March 26, 2007

DNR File No. DC-0105

Subject: Amendment of the *Dane County Water Quality Plan*, Revising the
Central Urban Service Area Boundary and Environmental Corridors within the Fobes
Portion of the Cottage Grove Neighborhood in the City of Madison.

Map 1
Amendment
to the Central
Urban Service Area,
City of Madison
Cottage Grove Neighborhood

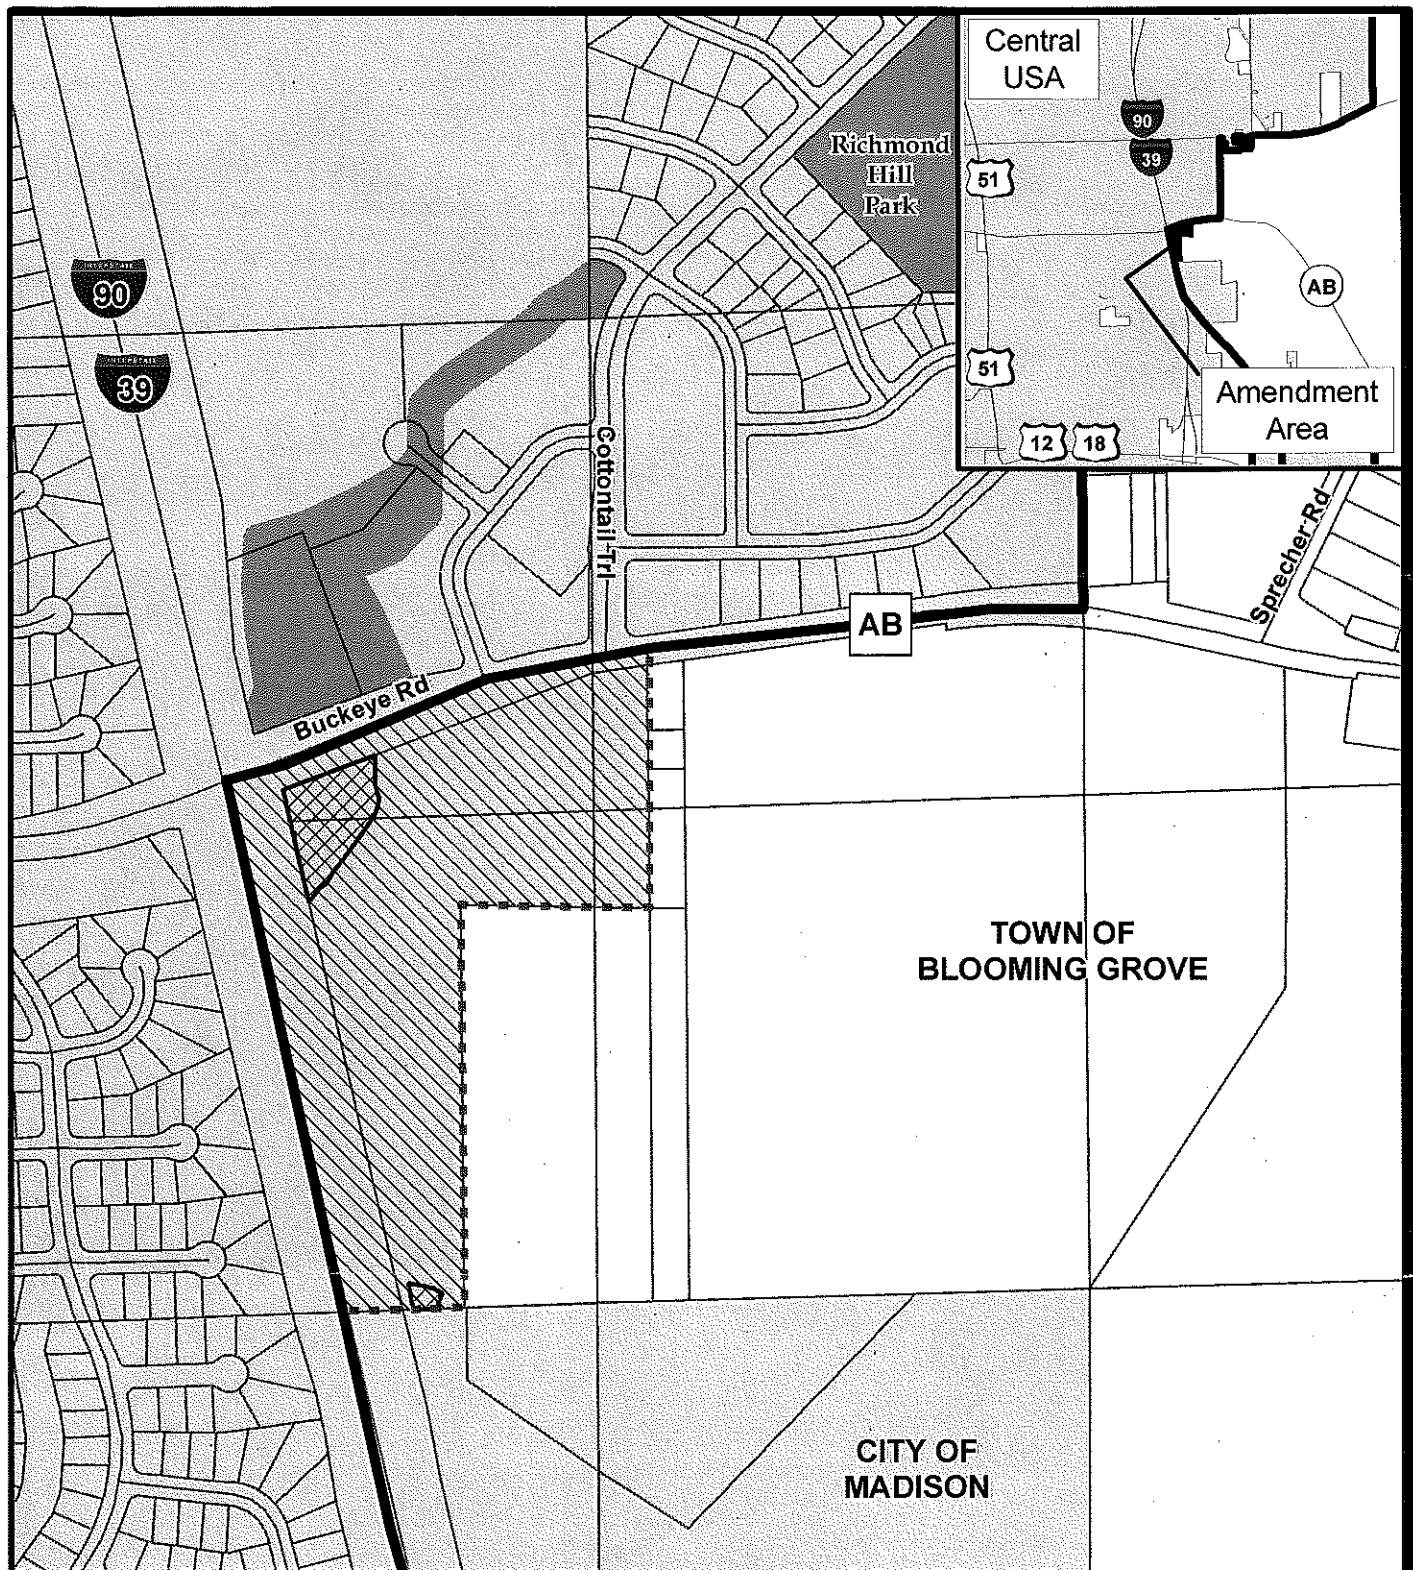
We have completed our review of the subject amendment request that was submitted to the Department on March 8, 2007 from the Dane County Community Analysis and Planning Division. The Department hereby approves this amendment request which adds 24.9 acres to the Central Urban Service Area, including 7.3 acres of existing right-of-way and 1.5 acres of environmental corridors, for a net developable area of 16.1 acres. The amendment area, also known as the Fobes property, is located east of Interstate Highway 39-90 and south of Buckeye Road and was annexed to the City of Madison on May 17, 2005. (see attached Map 1).

This Department approval is subject to the condition that the City of Madison complies with the conditions stated in the February 16, 2007 Staff Analysis. These conditions require the City to pursue the following:

Submit a detailed stormwater management plan for the amendment area for DC-CAPD and DCLCD staff review and approval prior to land disturbing activities. The stormwater management plan should maintain pre-development runoff rates for any discharge directly to the south of the amendment area, for all storms up to and including the 100-year storm. The stormwater management plan for the entire amendment area should protect the water quality of receiving streams, and prevent increased downstream flooding and erosion.

Include all stormwater management facilities in environmental corridors.

Provide stormwater infiltration to the maximum extent practicable.
